**From:** Joe Wang <joe.wang@impartner.com>  
**Sent:** Monday, December 15, 2025 6:03 PM  
**To:** Molly McGuire  
**Subject:** regarding SHL25-037 & SEP25-020

I received today in mail the public notice of application related to file SHL25-037 & SEP25-020. I have a question and hope you can help clarify.

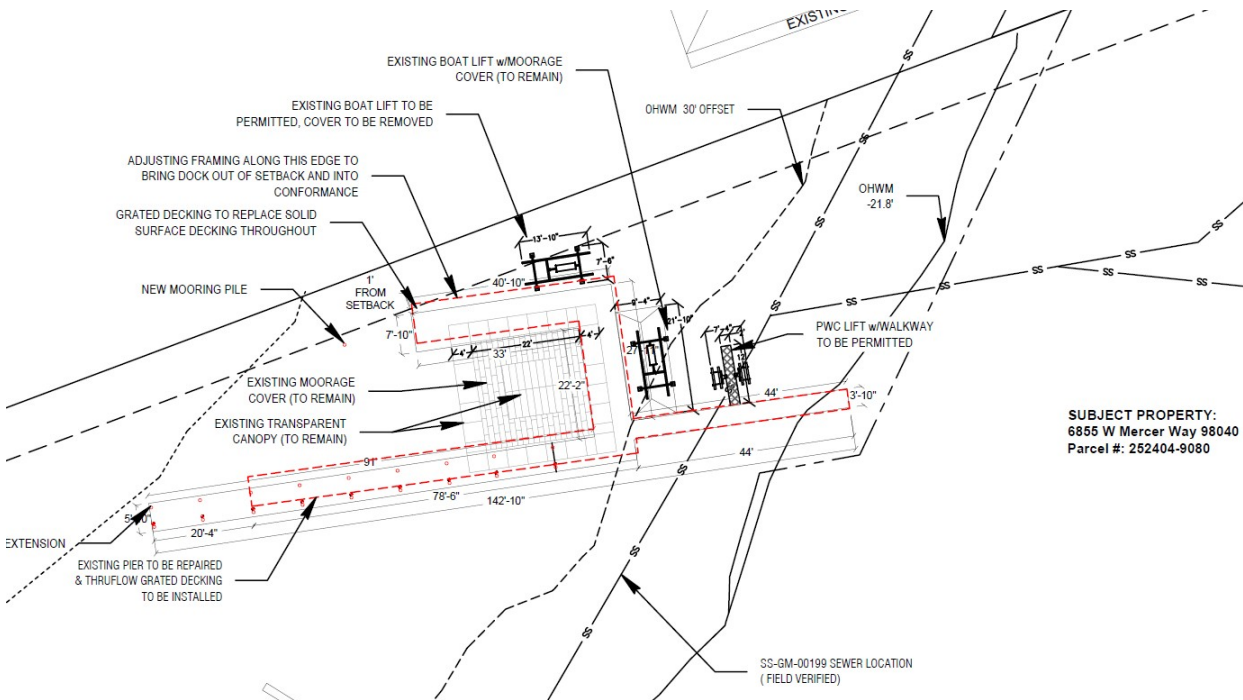
In file "Plan set 12-02-2025.pdf", it had this drawing as part of the "existing conditions":

However, this drawing does not appear to reflect the actual site conditions. In reality, there is no 'existing' pier as depicted. When the dock was constructed in 2021, it was not located within the 10-foot setback. Please see the attached City decision dated July 19, 2021, for reference. The approved configuration is shown below:

Please let me know if I have misunderstood. I would want to ensure that no new pier is constructed within the 10-foot setback or represented as an "existing dock to be repaired."
